ADDENDUM #1

Project: Ogden-Hinkley Airport
Remodel

Project Number: 2021-10

Date: 11.21.23

AD102

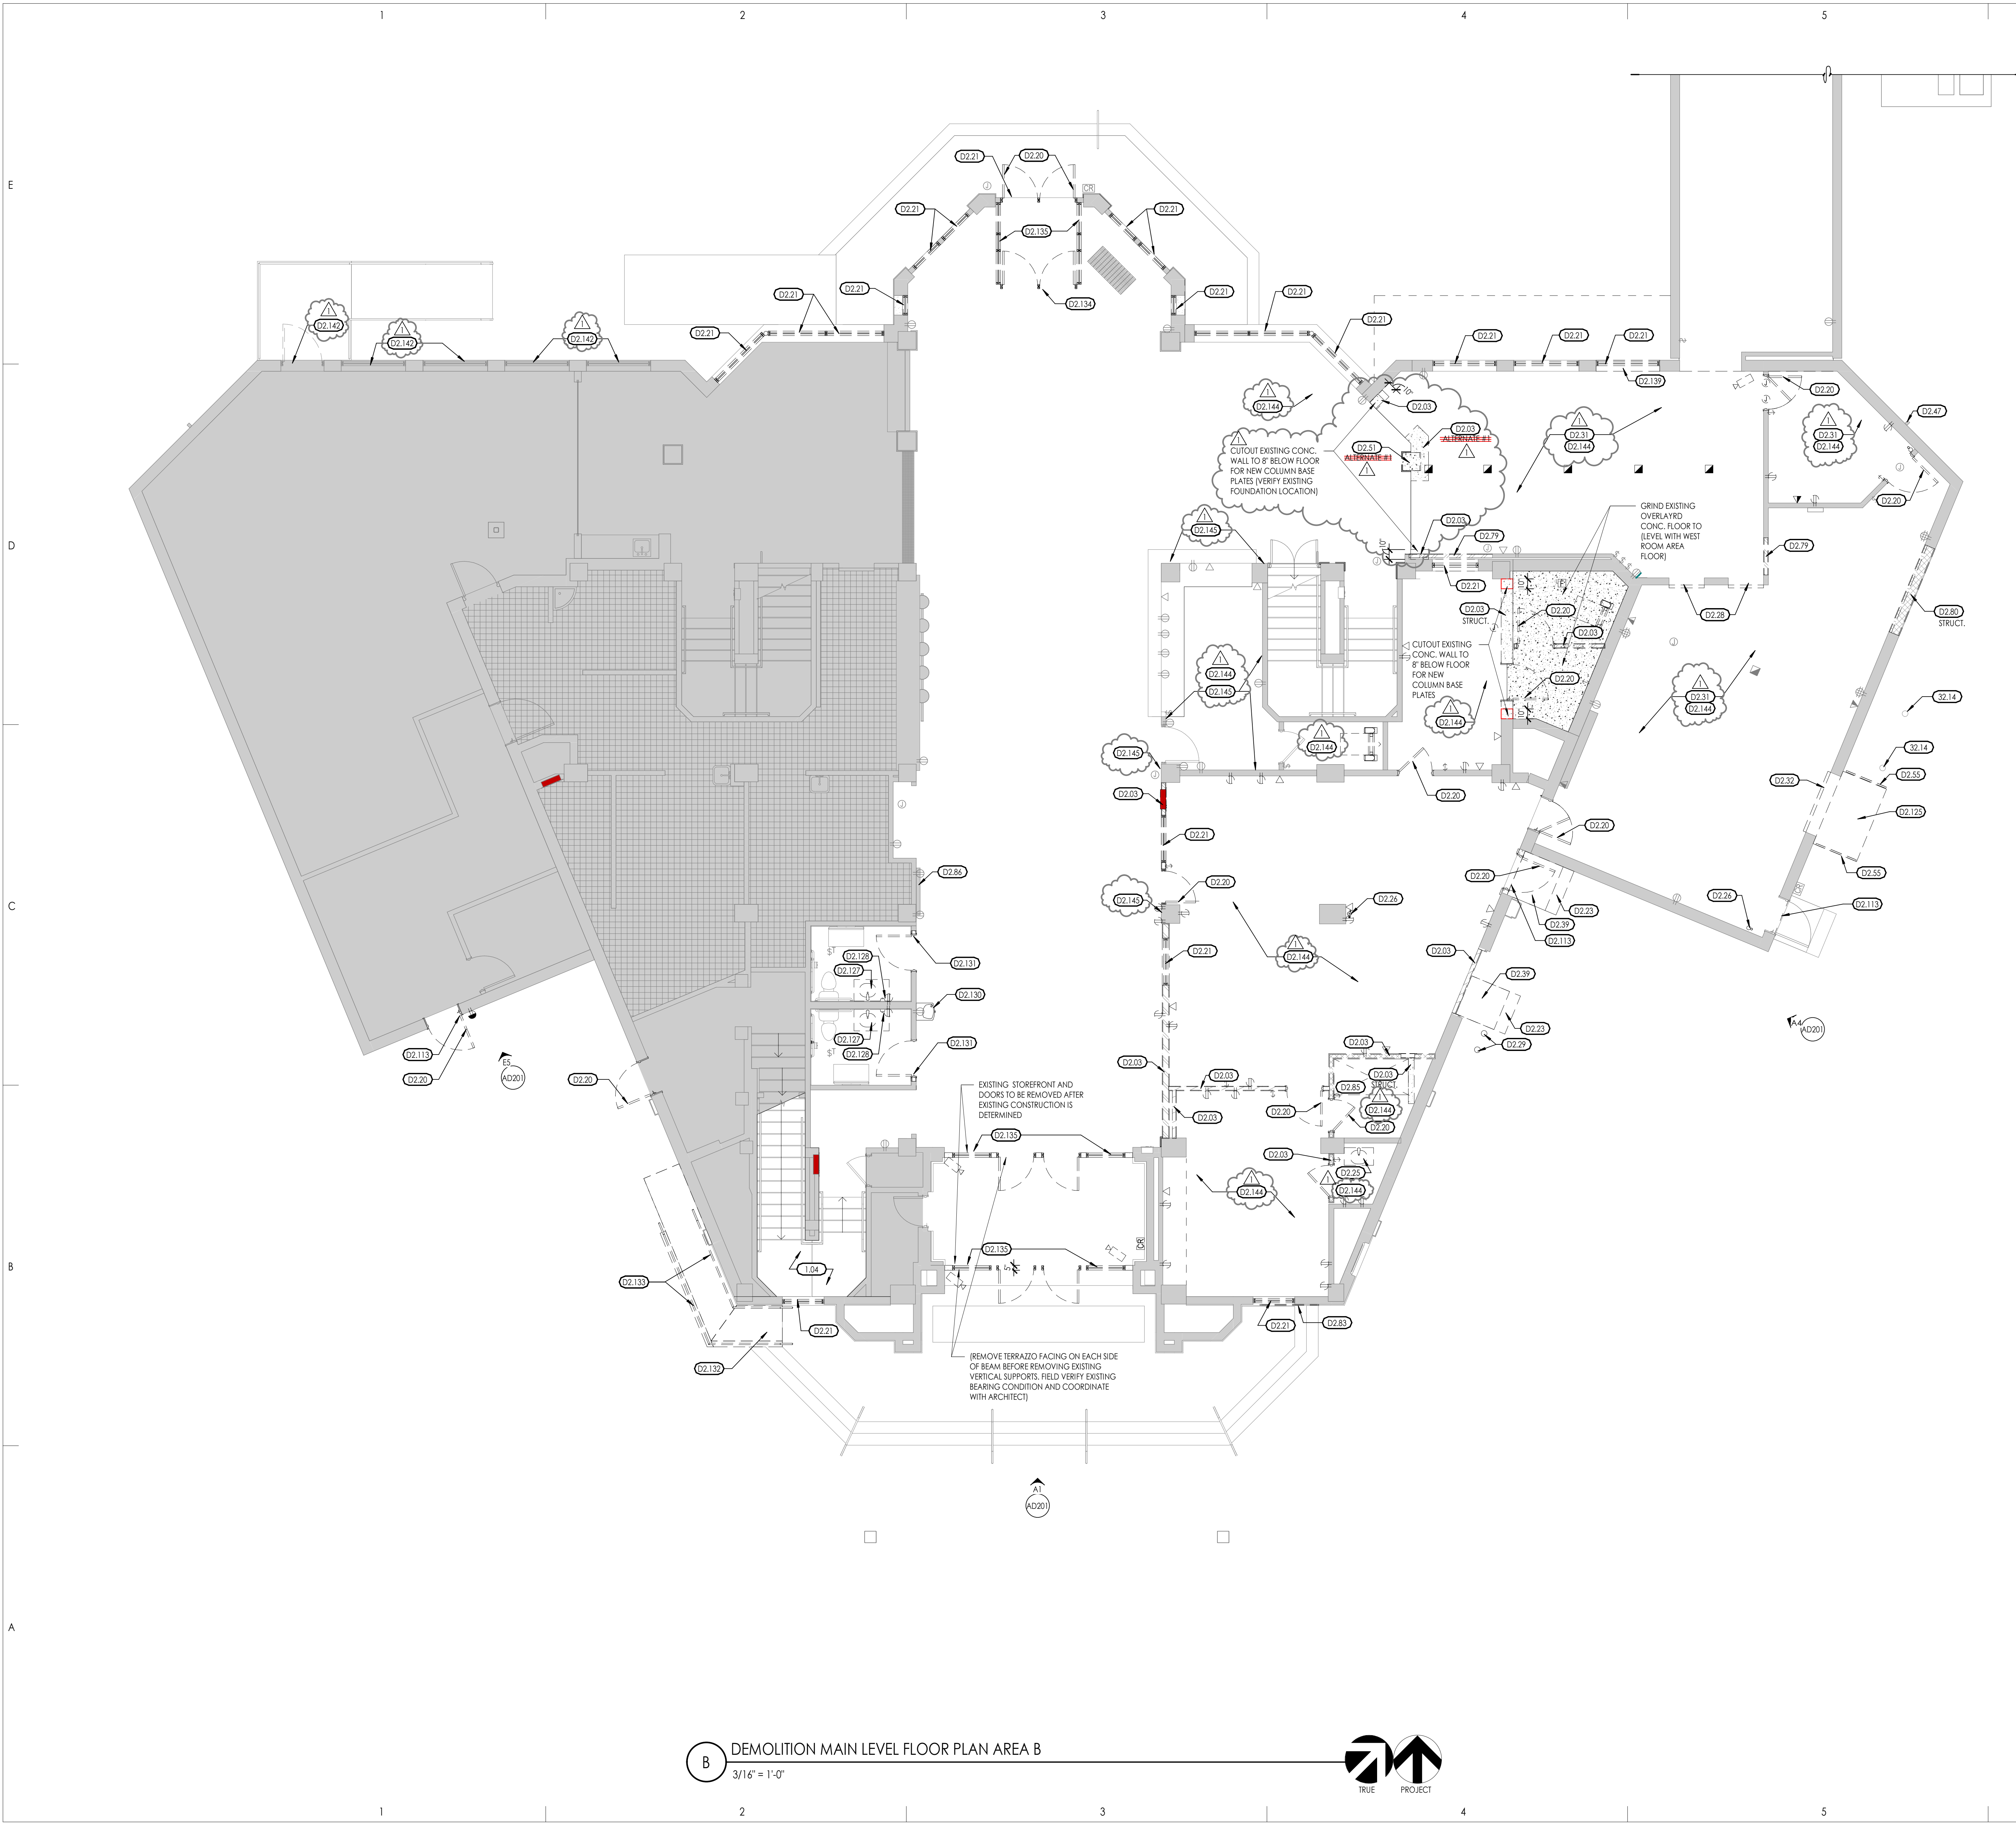
1. Drawing GI002:
 - A. Alternate #1, for removing the existing concrete column, is omitted. The work is to be included in the project.
2. Drawing AD102:

- A. Carpet indicated to be removed, stored on pallets and returned to Owner for storage. Keyed note 'D2.31' is added.
 - B. Rubber based indicated to remain in existing rooms indicated on drawing. Keyed Note: 'D2.143' is added.

- C. Rubber based indicated to be removed in the sloping floor concourse between buildings. Keyed Note: 'D2.144' is added.
 - D. The two door and frame locations indicated being removed.

- E. Cutout new door opening for double door installation. Shore bearing wall for new wall framing. Refer to Structural.
 - F. Some exterior windows are indicated to have the film removed from the glazing.

AD103

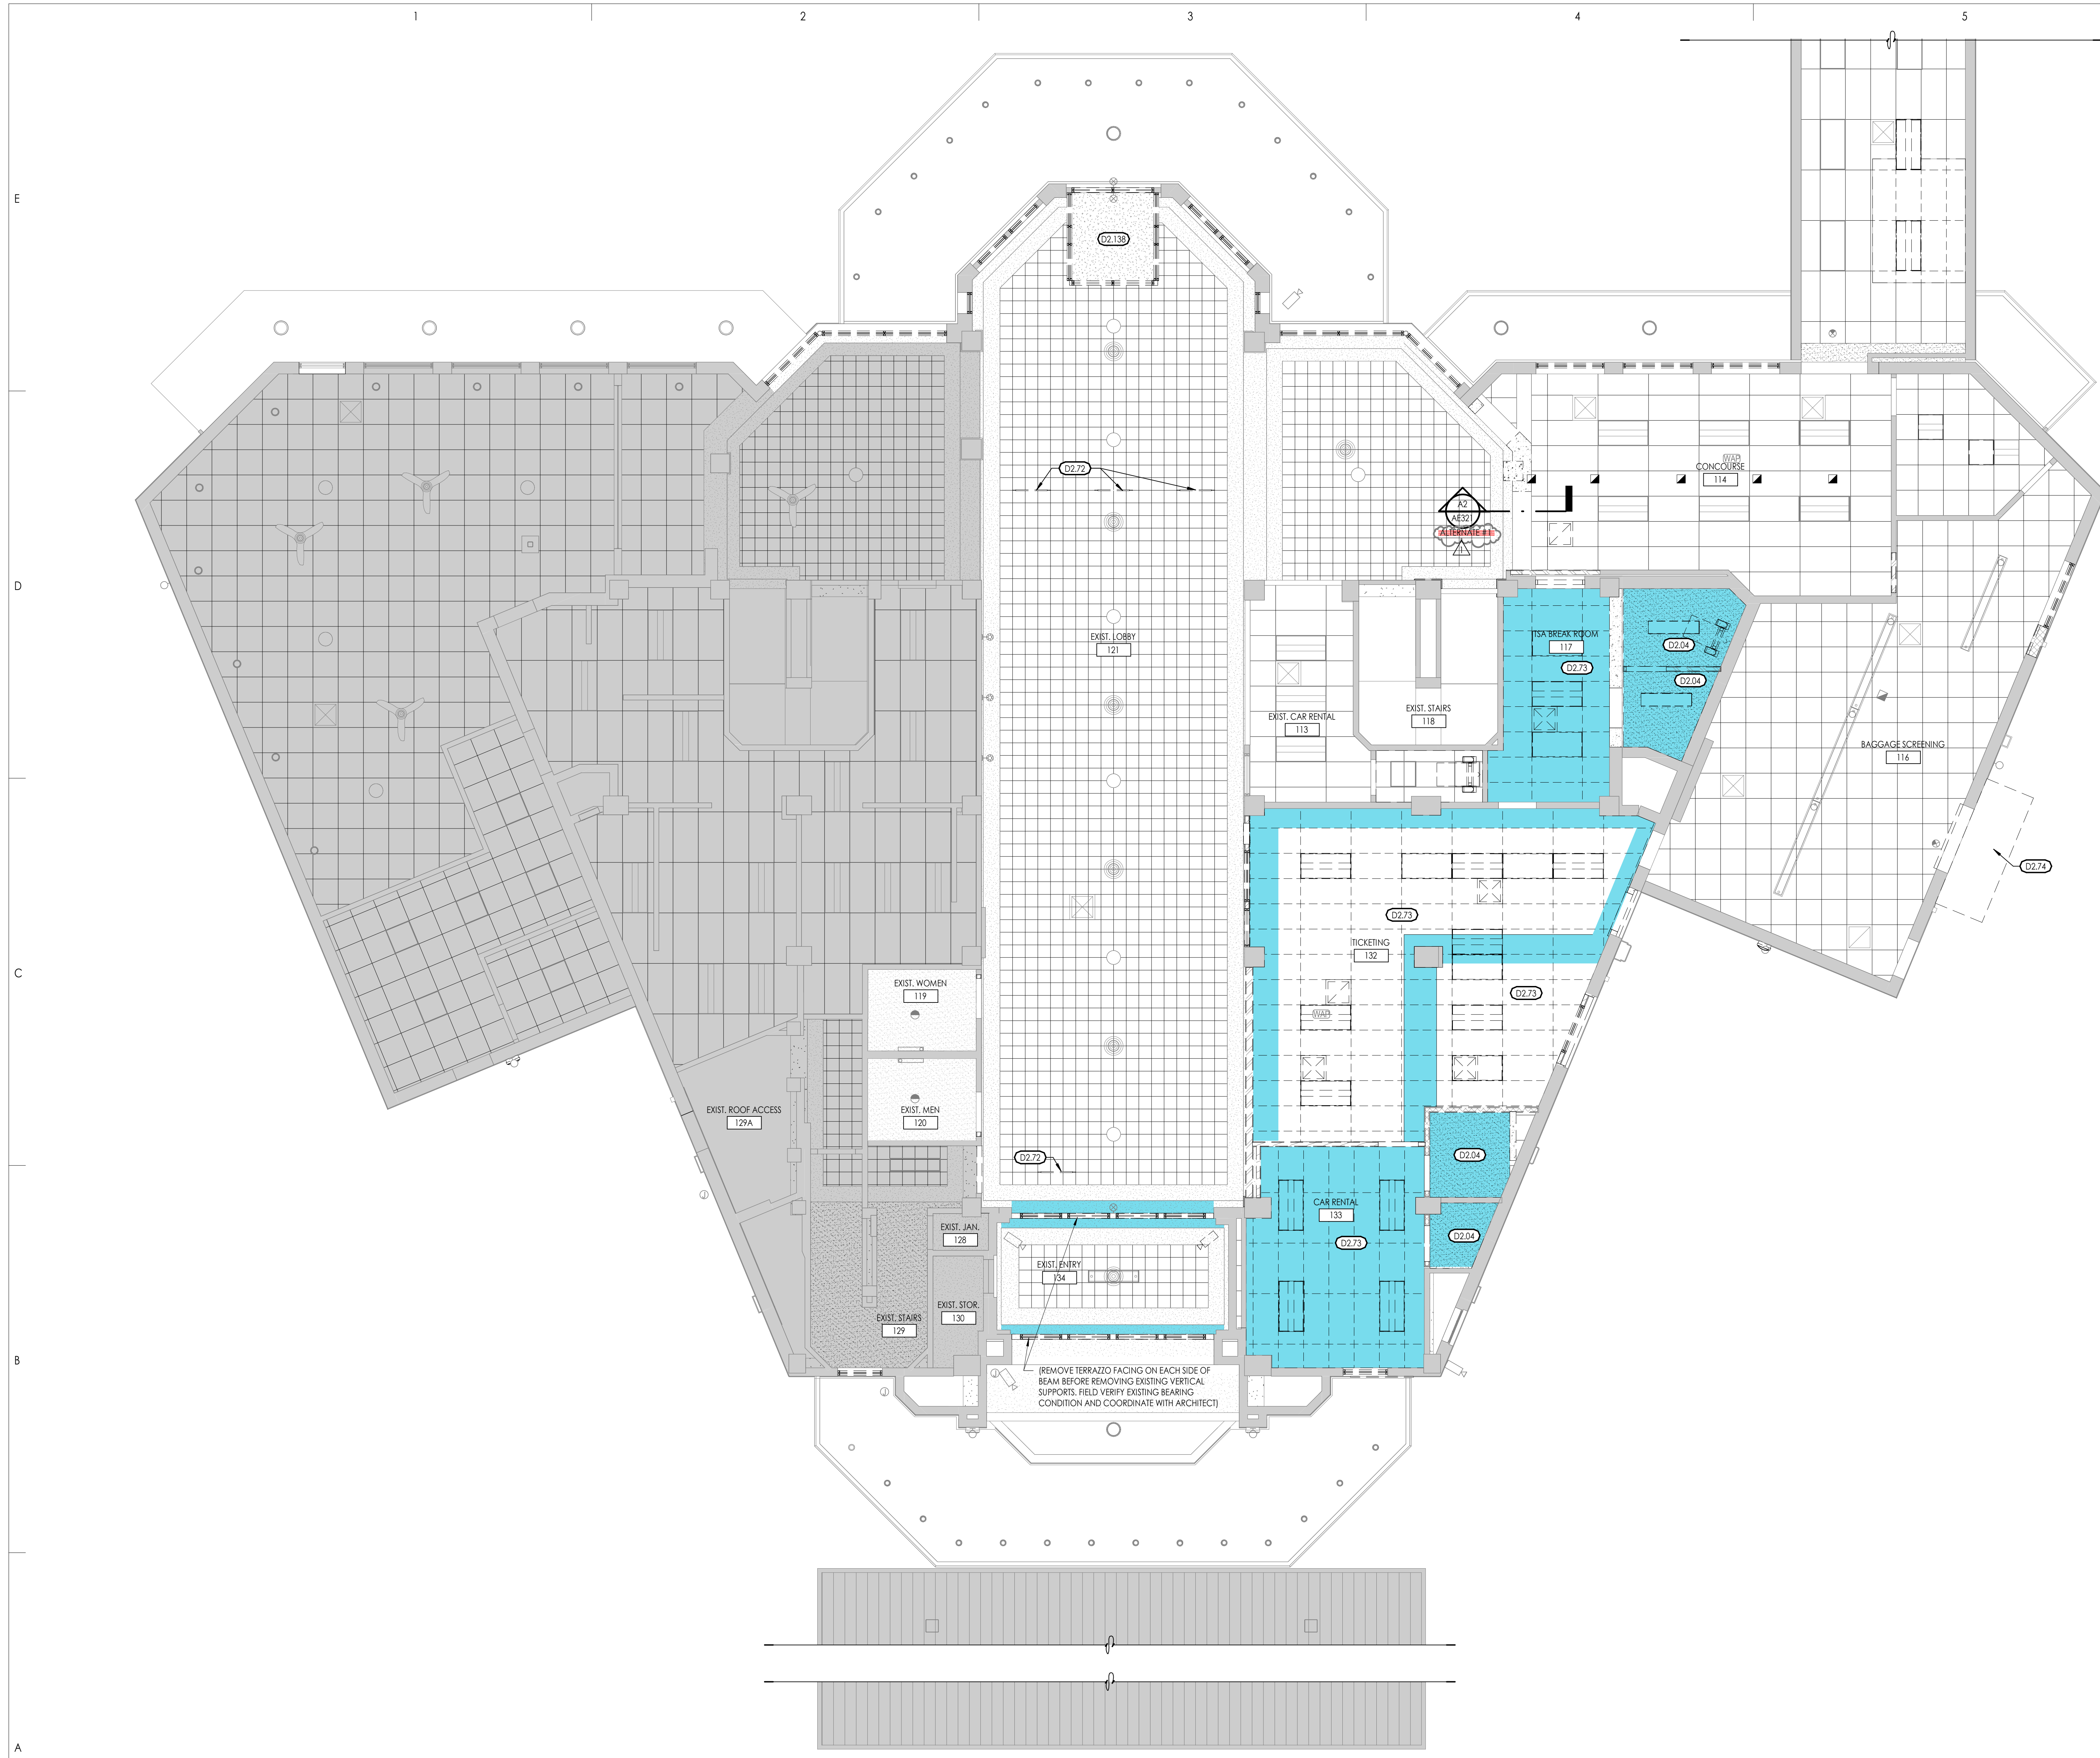
3. Drawing AD103:
 - A. Carpet indicated to be removed in rooms indicated, stored on pallets, and returned to Owner for storage. Keyed note: 'D2.31' is added.

- B. Rubber based indicated to be removed in the sloping floor concourse between buildings. Keyed Note: 'D2.144' is added.
 - C. Alternate #1 for removing the existing concrete column is omitted. The work is to be included in the project.

- D. Existing wall covering is to be removed. Keyed Note: D2.145' is added around the existing Car Rental area.
 - E. Some exterior windows are indicated to have the film removed from the glazing.
